Well Name: THEODORE ZINK	Well Location: T23N / R6W / SEC 15 / NWNW / 36.230667 / 107.461563	County or Parish/State: RIO ARRIBA / NM
Well Number: 1	Type of Well: OIL WELL	Allottee or Tribe Name:
Lease Number: NMNM23231	Unit or CA Name: THEODOR	Unit or CA Number: NMNM68170
US Well Number: 3003922923	Well Status: Producing Oil Well	Operator: ENDURING RESOURCES LLC

Type of Submission: Notice of Intent	Type of Action Plug and Abandonment
Date Sundry Submitted: 01/29/2021	Time Sundry Submitted: 10:42
Date proposed operation will begin: 02/01/2021

Procedure Description: This sundry was originally submitted on 6/11/2020. It was rejected due to the WIS transition to WISX. Enduring Resources requests to plug and abandon the above mentioned well per plugging procedure, wellbore diagram and reclamation plan.

BLM FLUID MINERALS Geologic Report

PROPOSED P&A WELLBORE DIAGRAM

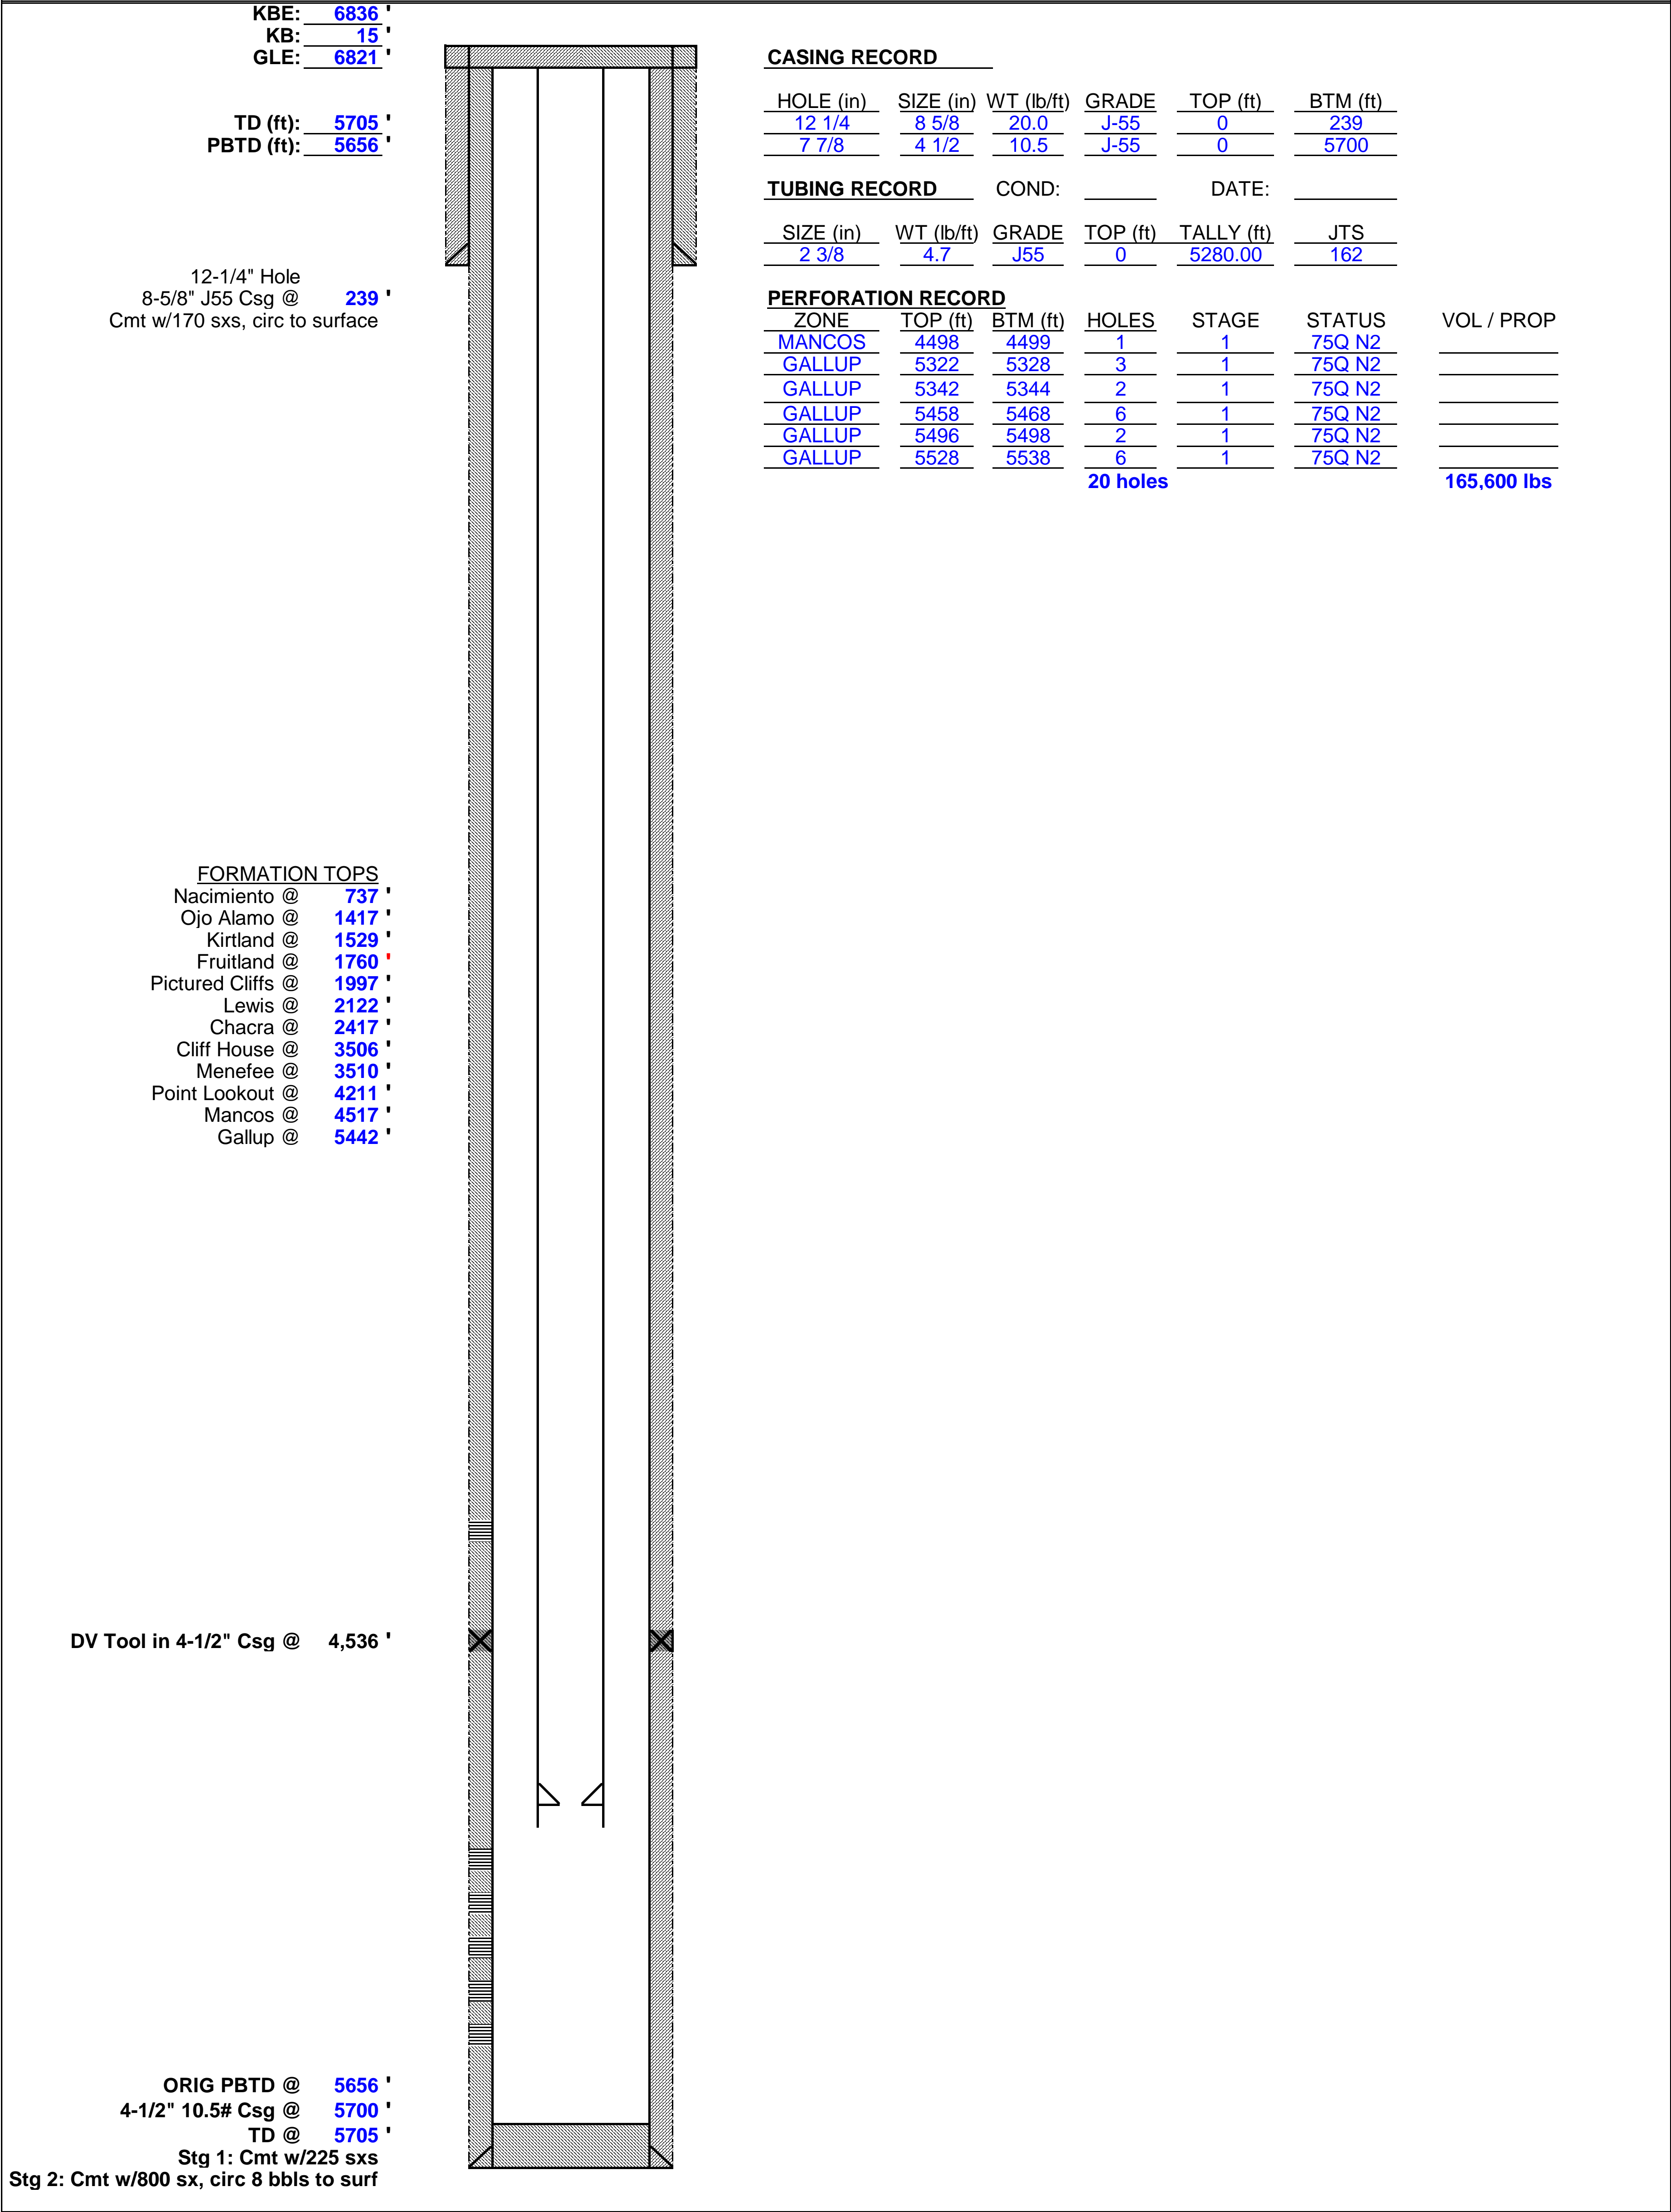
- Please ensure that the tops of the Pictured Cliffs and Fruitland formations as well as the entire Ojo Alamo aquifer, identified in this report, are isolated by proper placement of cement plugs. This will protect the freshwater sands in this well bore.
